City of Tarpon Springs, Florida

Heritage Preservation Board

REGULAR SESSION AGENDA MONDAY, NOVEMBER 4, 2024 6:30 PM - CITY HALL AUDITORIUM

36 N Spring Boulevard, Jacob Disston House
STAFF REPORT

155 E TARPON AVE – PROPOSED PROJECT

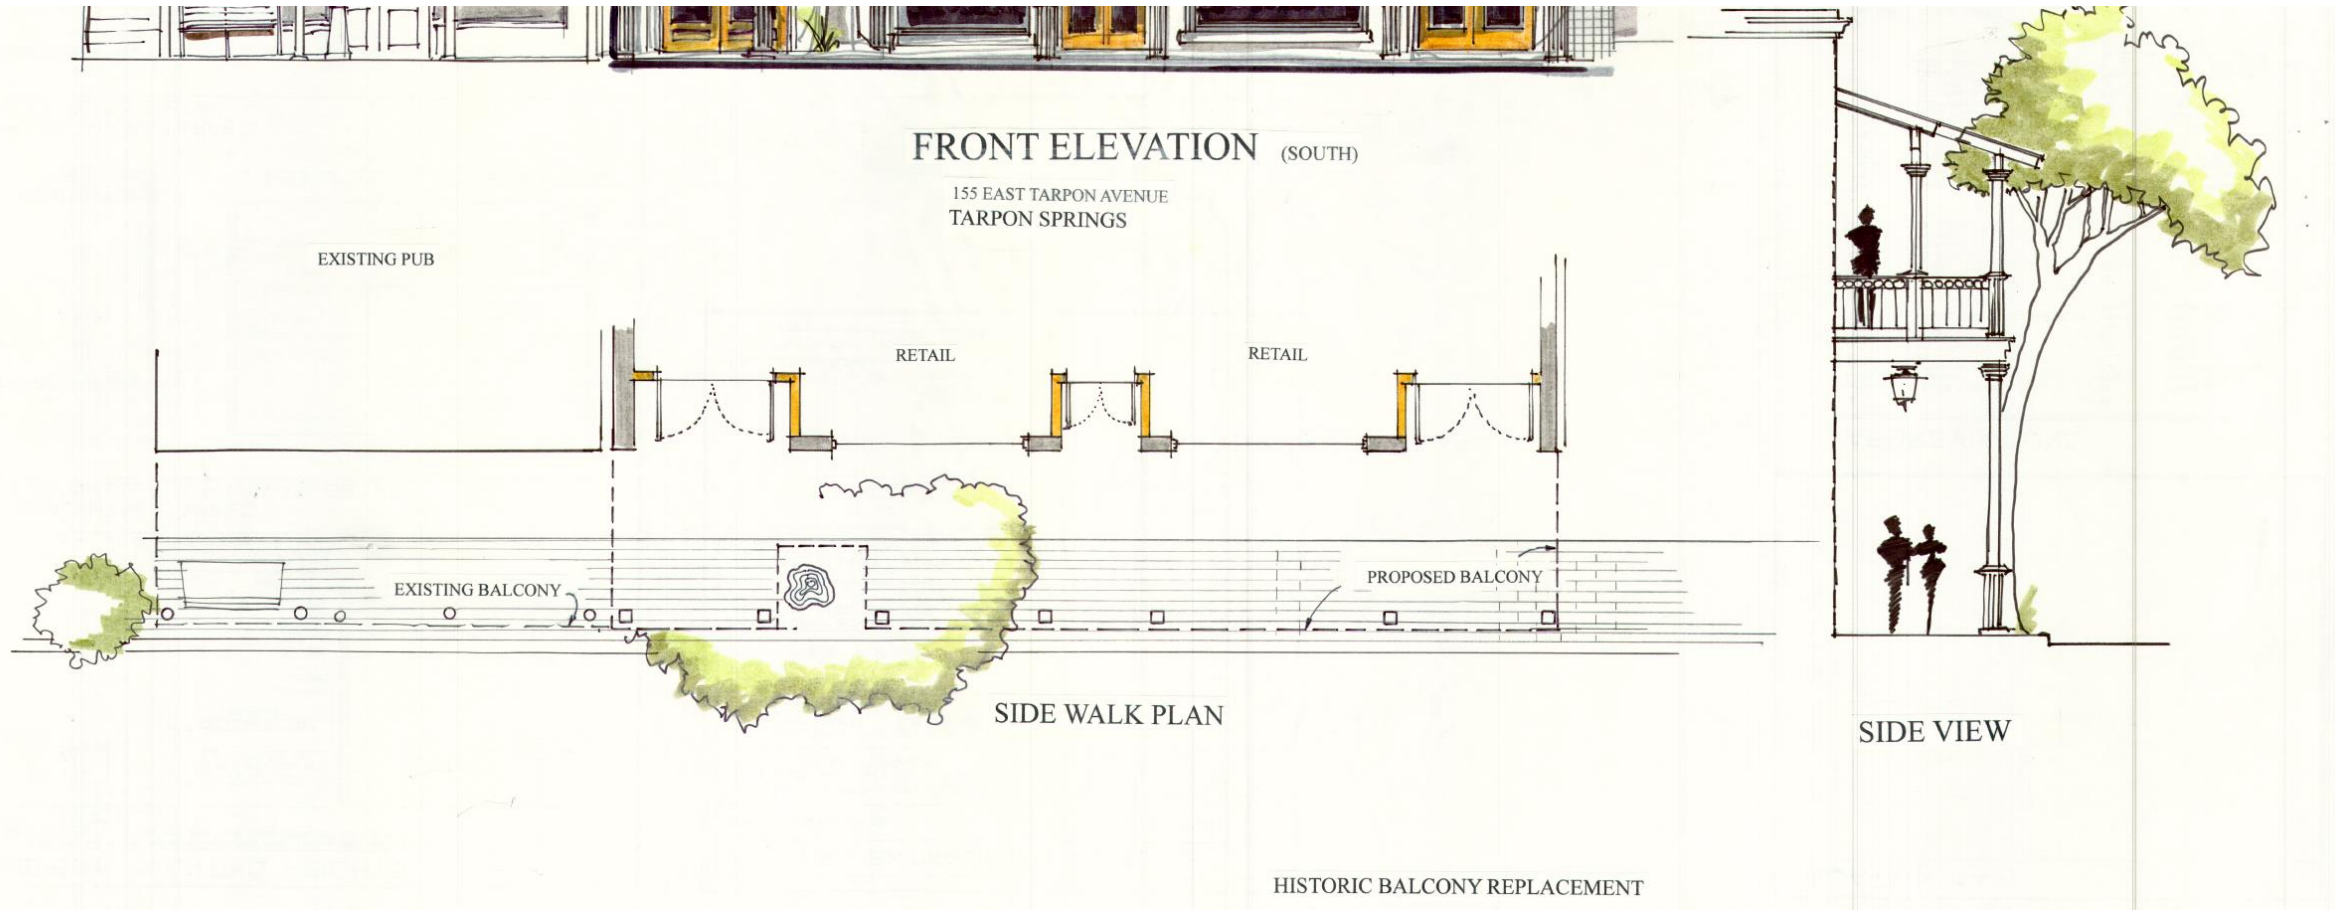
ANALYSIS: The replacement of the balcony will restore a historical feature of the subject building and its relationship to the public realm. Historically, buildings along Tarpon Avenue utilized awnings and balconies to provide respite from the weather for passersby and patrons. The replacement of the balcony at the subject building will restore this functional and physical relationship between private property and the public realm.

1. The balcony and transom restoration will be constructed as illustrated in the application. Any deviation from plans require consultation with City staff prior to construction and may require additional approvals from the HPB.
2. Specific product information for building materials will be provided with the building application and reviewed for consistency by City staff.
3. The Certificate of Approval will expire in three (3) years if a building permit has not been issued for the project.

PROPOSED PROJECT

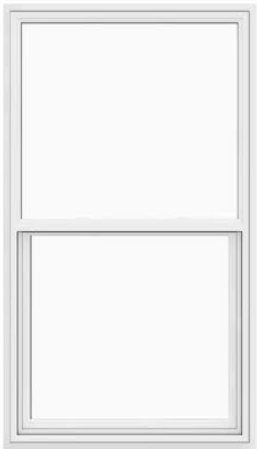
ANALYSIS: The proposed project would replace aluminum windows that are not original to the structure with vinyl windows that would generally visually replicate historic windows. The configuration of the 1/1 proposed replacement windows would be consistent with the property's original architectural style and character. However, the use of vinyl would not fully replicate the visual qualities of the original wood windows.

ANALYSIS: The proposed project is expected to be constructed in compliance with the Land Development Code and the Florida Building Code. The proposed project can be interpreted as balancing the goals, objectives, and policies of the Comprehensive Plan because it does not involve destroying original materials and will increase the longevity of the structure. However, the proposed project does not fully comply with the Secretary of the Interior's Standards for Rehabilitation and Guidelines for Rehabilitating Historic Buildings because the material proposed (vinyl) does not fully visually replicate the original wood windows.
